## Raleigh Historic Development Commission – Certificate of Appropriateness (COA) Application

## 418 SOUTH BOYLAN AVENUE - BOYLAN HEIGHTS

### APPLICATION FOR A CERTIFICATE OF APPROPRIATENESS – STAFF REPORT

101-17-CA 418 S BOYLAN AVENUE Applicant: MEG MCLAURIN, AIA

SLEEPING PORCH WINDOWS MISMATCHED & ILL FITTING

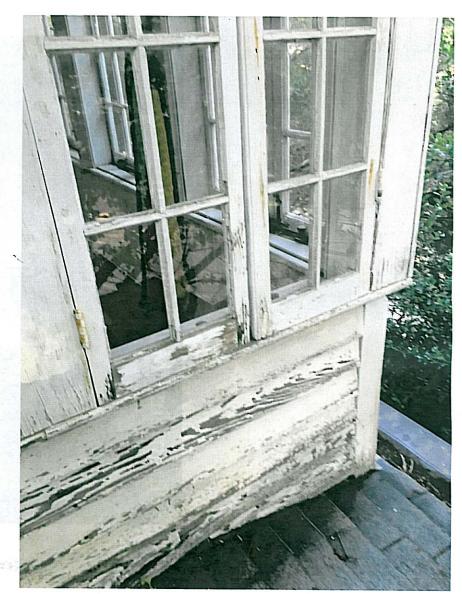
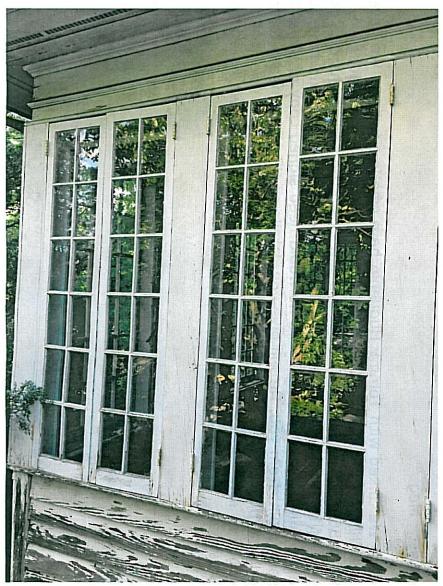
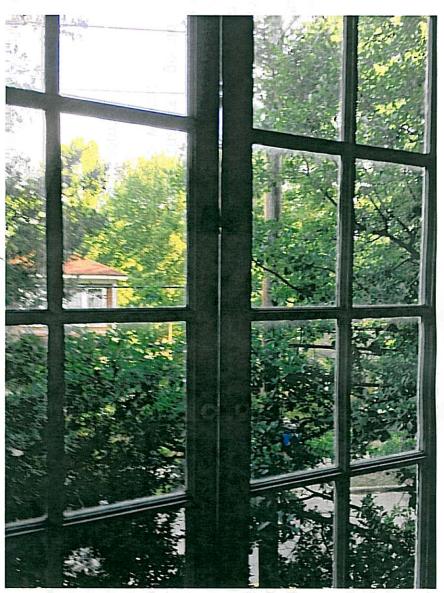
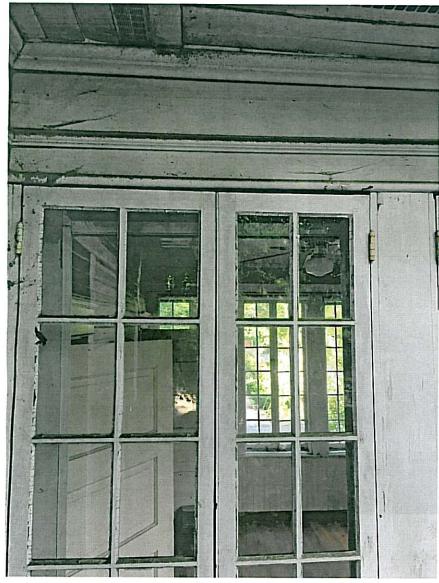
- B. Replacement of sleeping porch windows is not incongruous in concept according to *Guidelines* 2.7.1, 2.7.11, and the following suggested facts:
- 1\* Based on the Sanborn Fire Insurance maps from 1914 and 1950, the addition and sleeping porch on the south side were constructed outside the period of significance of the historic district.

- 2\* Photographs show that the windows are inconsistent in light size and are ill fitting.
- 3\* The proposed new windows fit within the existing openings and are wood multi-light casement windows. Specifications and details were not provided.

418 S Boylan Ave West Elevation

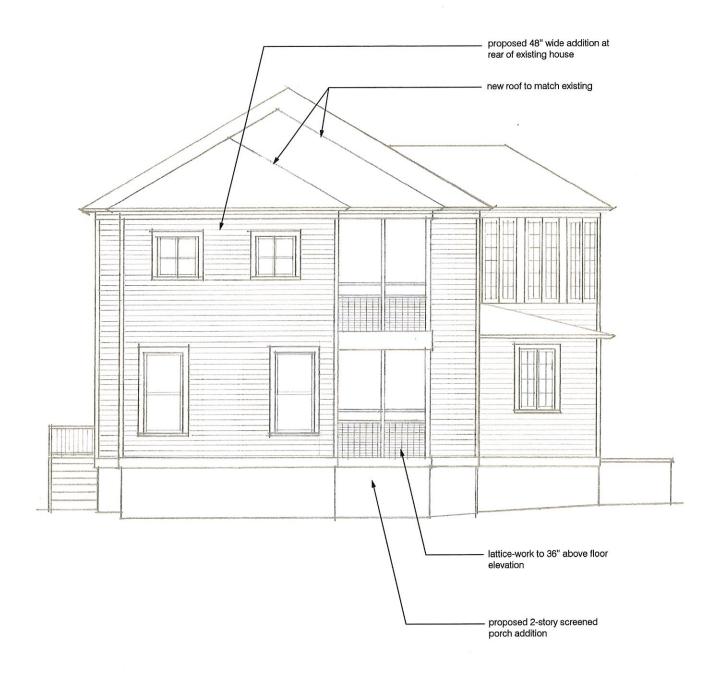
- 5\* Eave, siding, and trim details will match the existing. However, no information is contained in the application regarding details for the construction of the screen porch, including flooring, handrails, posts, beams, and ceilings.

- 6\* Foundation brick is currently painted; the application proposes to match all paint colors and treatments.
- 7\* Window and door pattern and proportions are characteristic of the house. It is not clear from the application which windows might be new, and which windows might be relocated. No information is provided in the application regarding manufacturer details for new window and door units.

- 1. That staff review and approve the following details prior to the issuance of building permits:
  - Tree protection plan;
  - Screen porch details, including flooring, handrails, posts, beams, and ceilings;
  - Manufacturer details for new windows and doors.
